Neal McAilley
Shareholder
(305) 530-4039 Direct Dial
nmcailley@carltonfields.comAtlanta
Florham Park
Hartford
Los Angeles
Miami
New York
Orlando
Tallahassee
Tampa
Washington, D.C.
West Palm BeachColonel James Booth
Commander, Jacksonville District
U.S. Army Corps of Engineers
701 San Marco Blvd.
Jacksonville, Florida 32207Re: Western Everglades Restoration Project – Tentatively Selected Plan

I am writing to provide comments of the Bergeron Everglades Foundation on the proposed “tentatively selected plan” for the Western Everglades Restoration Project (“WERP”). We have significant questions about how the proposed WERP plan, which has been designated “Alternative Hr,” will affect natural resources in southern Hendry County, and we ask that the Corps address these questions before making any decisions to tentatively select any WERP plan.

Source: SFWMD Presentation to WERM PDT Meeting (May 30, 2017)

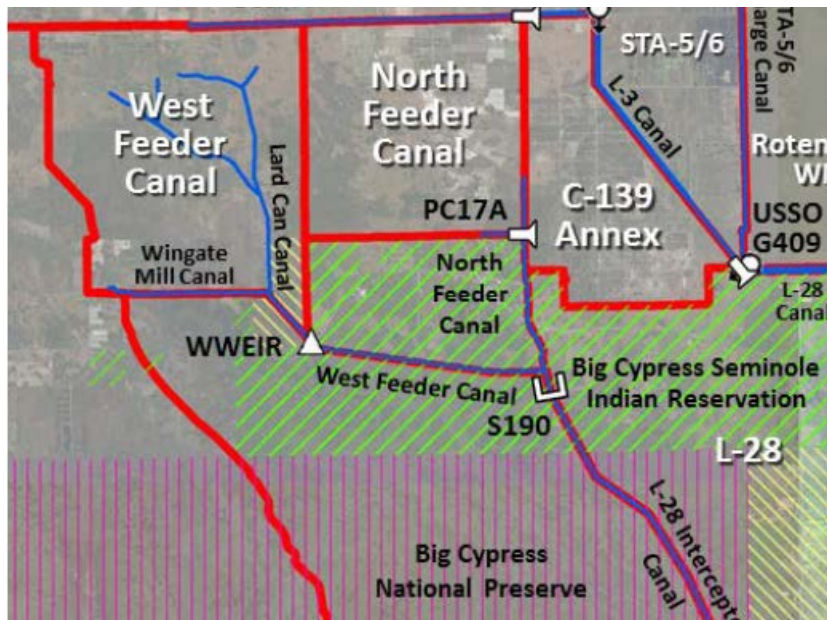
and the West Feeder Canal. The West Feeder Canal, which is the focus of our concern, receives water from two smaller canals, the Lard Can Canal and the Wingate Mill Canal. These latter two canals drain the area west of the Reservation in southern Hendry County. A figure showing the location of the canals is shown below:

This canal network limits surface inflows to the areas south of the West Feeder Canal and Wingate Mill Canal. Maps prepared by the agencies in WERP process show the areas south of the West Feeder and Wingate Mill Canals as having “no existing direct discharge.” The primary water source for the Kissimmee Billy Strand and other nearby areas is local rainfall. This means that for at least sixty years (if not longer), the flora and fauna in Kissimmee Billy Strand and nearby areas have lived with water levels determined by rainfall and very low phosphorus levels.

Source: USACE, Presentation to WERP PDT (June 2020).

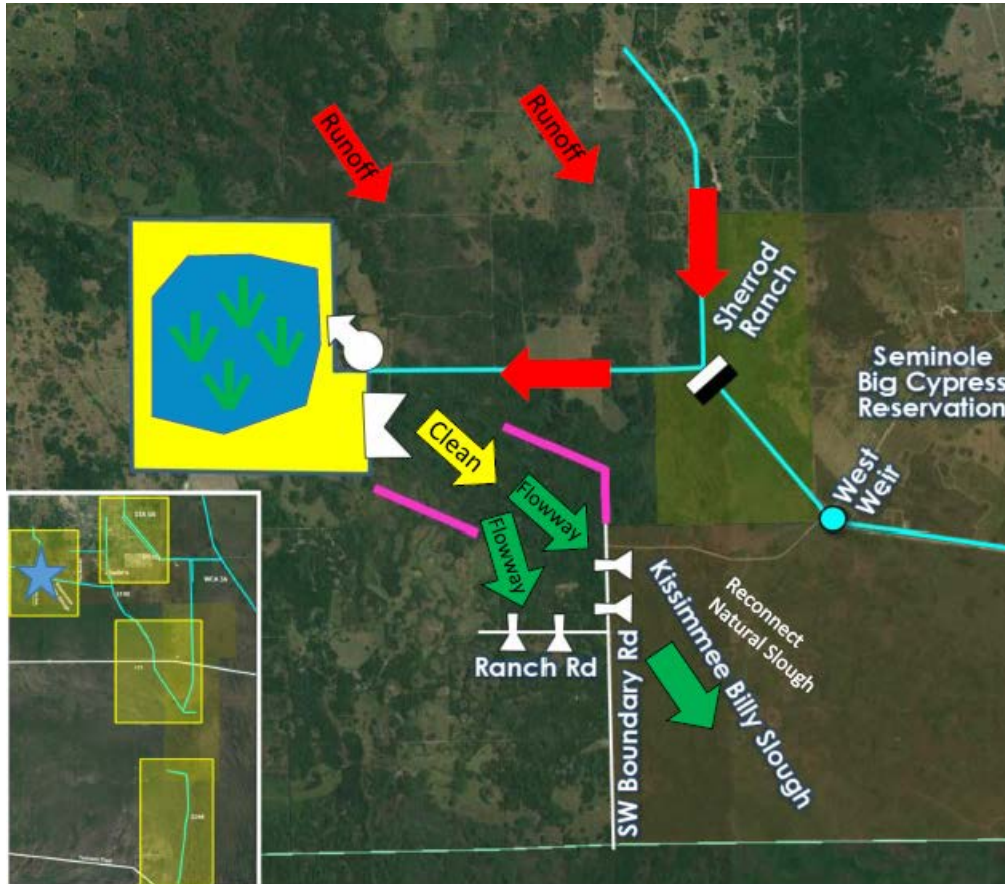
Lard Can and Wingate Mill Canals (approximately 41,000 acre feet/year), treat it, and then discharge it south into the Kissimmee Billy Strand. The following figure diagrams the proposed plan in this area:

The Wingate Mill STA in Alternative Hr would be located directly on top of a portion of Kissimmee Billy Strand. Kissimmee Billy Strand runs for several miles across southern Hendry County and eastern Collier County. In the area where the Wingate Mill STA is proposed to be built, the Kissimmee Billy Strand is in excellent ecological conditions, with old growth cypress trees and rare native plants. This area has been identified as primary habitat for the Florida panther, and there are regular sightings of the cats there. Most people are unaware that the STA is proposed to be located on such a beautiful natural habitat, because it is shown as a blank area on WERP project maps.

Construction of the STA likely would severely impact, if not destroy, that portion of Kissimmee Billy Strand. The STAs built elsewhere in South Florida all are managed, emergent wetland systems. As part of building those STAs, the agencies grade the land so that water

Source: USACE, Presentation to WERP PDT (Aug. 2016).

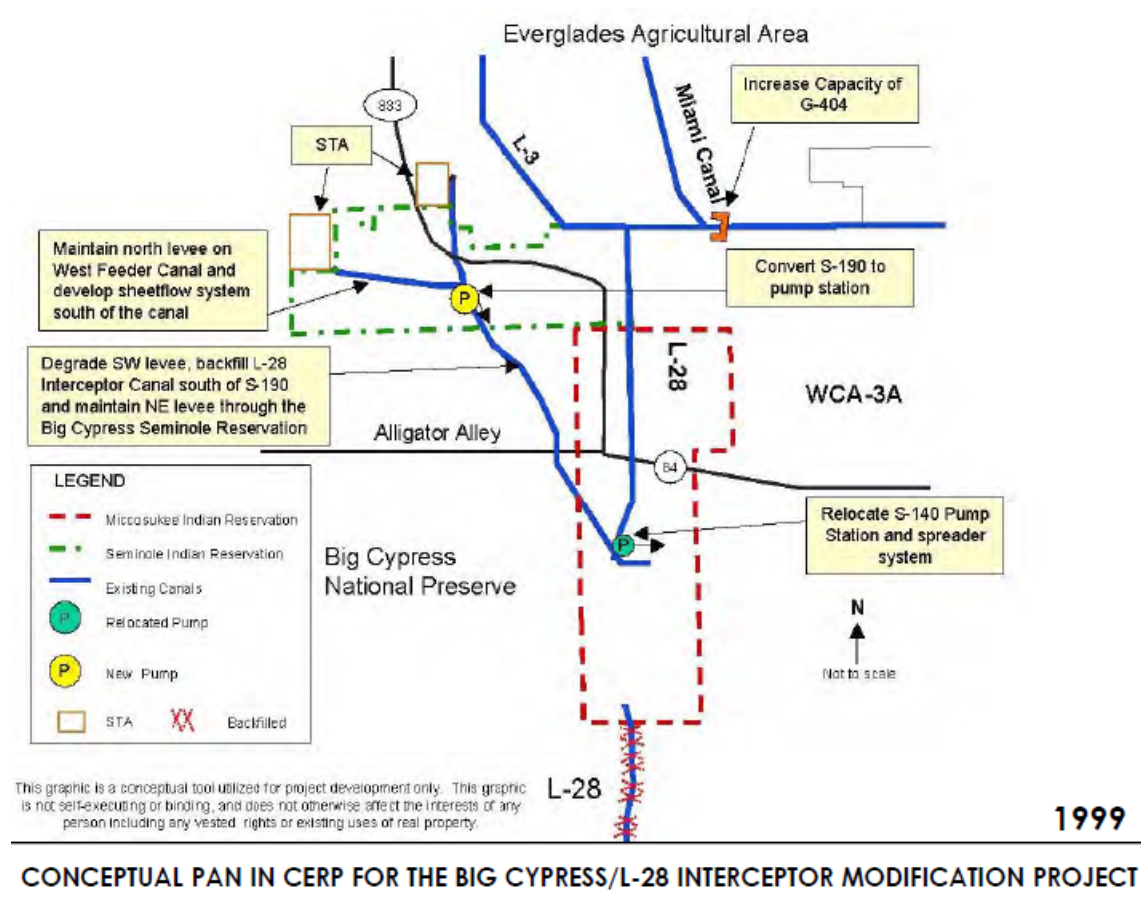
The current proposed WERP plan is very different than the project identified in the original Comprehensive Everglades Restoration Plan (“CERP”). CERP included Component CCC, “Big Cypress/L-28 Interceptor Modifications.” Component CCC would have maintained the existing drainage patterns in the West Feeder Basin, so that water in the Lard Can Canal and Wingate Mill Canal would continue to flow into the West Feeder Canal and thence onward to the L-28 Interceptor. This plan would have built a small stormwater treatment area at the western end of the West Feeder Canal to improve water quality in the L-28 Interceptor. Component CCC also would have degraded the southern levee of the West Feeder Canal so that water would sheetflow across several miles of the Reservation and enter the Preserve. A schematic description of the original CERP plan is shown below:

The current WERP proposal in substance is quite different than Component CCC. Alternative Hr would block all flow into the West Feeder Canal, and reroute water from the Lard Can Canal west to the Wingate Mill STA. The Wingate Mill STA is located several miles west from where it was located in Component CCC, and is much larger. Also, instead of allowing for sheetflow from the West Feeder Canal across several miles of the Reservation, Alternative Hr pushes water discharges west and would concentrate the discharges in the area downstream of the Wingate Mill STA. Alternative Hr essentially pushes water and project features away from the Reservation and relocates them to the privately-owned areas of southern Hendry County.
